No. RW/BNG/PER.CASES/MNG.DVN/2013

Notice Inviting Public Comments on proposal seeking permission to laying of water pipeline for drinking water scheme along NH 275 from Kabaka Km 10.200 to Km 10.850 on LHS (650 m), from Km 10.850 to Km 11.100 on LHS (250 m), from Km 11.100 to Km 11.400 on LHS (300 m), from Km 11.400 to Km 12.000 (600 m) on LHS, Km 12.000 to Km 12.400 (400 m) on LHS, from Km 12.400 to Km 13.600 (1200 m) on LHS, Km 13.600 to Km 14.150 on LHS (550 m), from Km 14.150 to Km 16.200 on LHS (2050 m), and from Km 16.200 to Km 16.450 on RHS (250 m), from Km 16.450 to Km 16.850 on RHS (400 m), from Km 16.850 to Km 18.100 on RHS (1250 m) for a total length of 7.90m through open trench method and three road crossings at Km 11.400, Km 14.100 & Km 16.850 through HDD method in the State of Karnataka by Municipal Commissioner, Puttur City Municipal Council - reg.

Sub: Request for permission to lay Water pipe line by open trench method and road crossing only HDD method from KUID & FCL, Puttur Division, Drinking Water Scheme along NH-275 Kabaka from Km.10.200 to Km.10.850 on LHS (650), from Km 10.850 to Km 11.100 on LHS (250), from Km 11.100 to Km 11.400 on LHS (300), from Km 11.40

PROPOSED PIPELINE ALIGNMENT DWG FOR NH-275

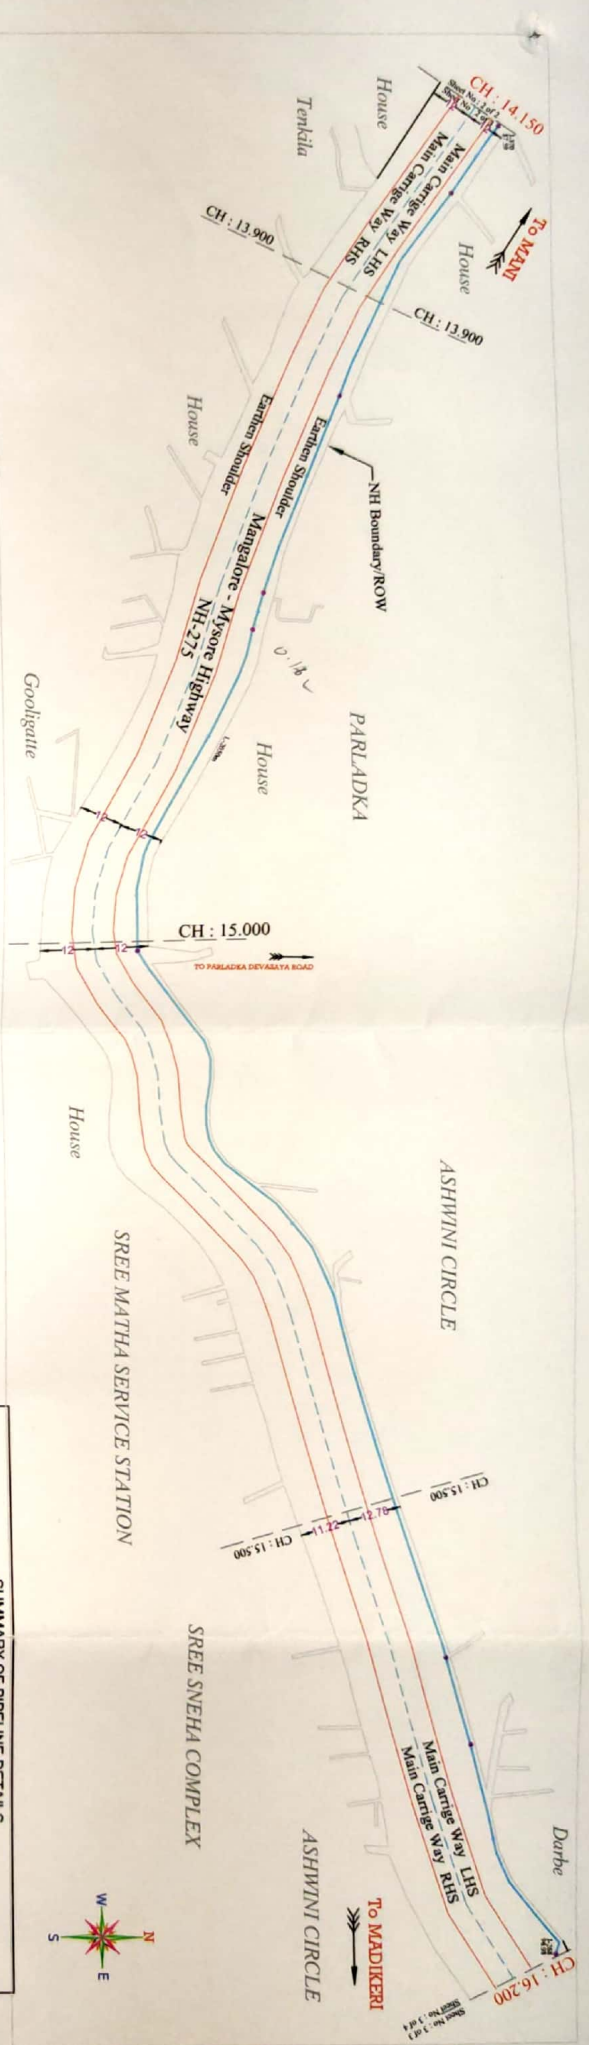
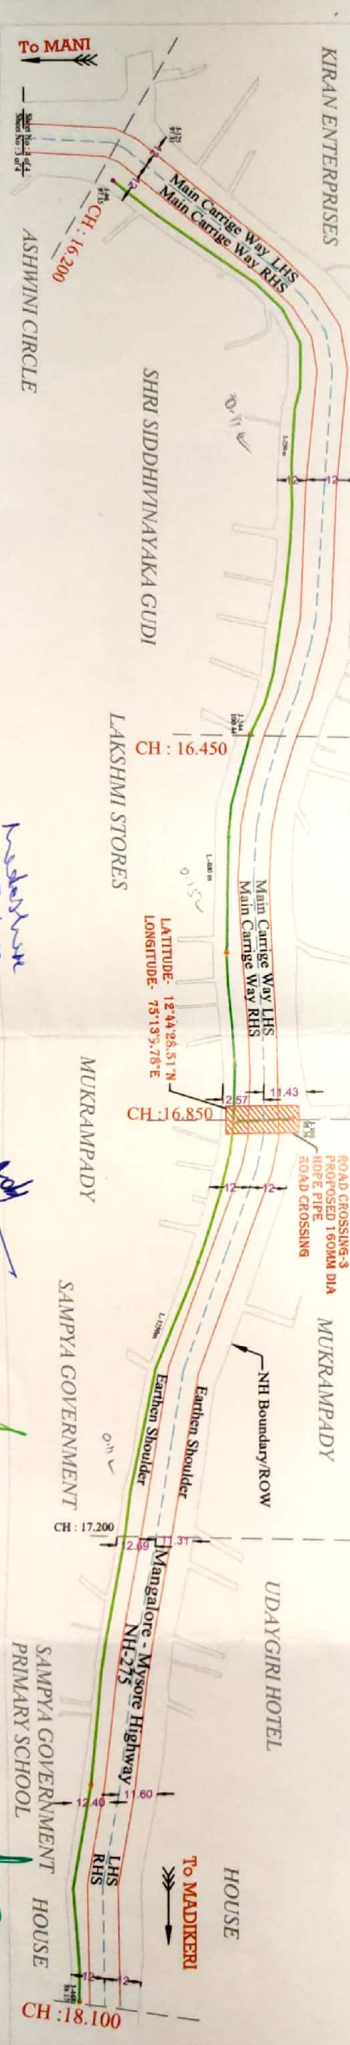
Sl. No.	Observation	Compliance
1	The laying of water pipeline is proposed on both side of NH. The proposal needs to be examined in light of future widening to 2 lane + Paved shoulder and 4 laning for which the entire available land in ROW is required. Further, corridor of impact of widening work w.r.t. the available ROW may also be examined.	Now the laying of water pipeline is proposed on one side of National Highway. Resubmitted modified all drawings, check list etc.
2	The proposed work becomes a obstruction for the widening of NH road in near future. This will hamper future improvement of National Highway. Hence, lying of pipeline on alternate route or in single side of National Highway may be explored.	Now the laying of water pipeline is proposed on one side of National Highway.

3.	In the enclosed proposal, the chainages mentioned in the proposed drawings and in the license fee calculation is not matching and for calculation of license fee all the proposed pipelines needs to be considered. As such the Executive Engineer, National Highway Division, Mangalore is requested to examine the proposals thoroughly as per Ministry's guidelines and see that the proposal is properly prepared in the file format and submitted to this office, to avoid delay in processing the proposals.	The chainages of proposed drawings and license fee calculation is now corrected and resubmitted by the KUID & FCL, Puttur Division. The license fees calculation sheet and BG calculation sheets are enclosed in Annexure - I and Annexure - II. The proposal is verified and herewith submitted.
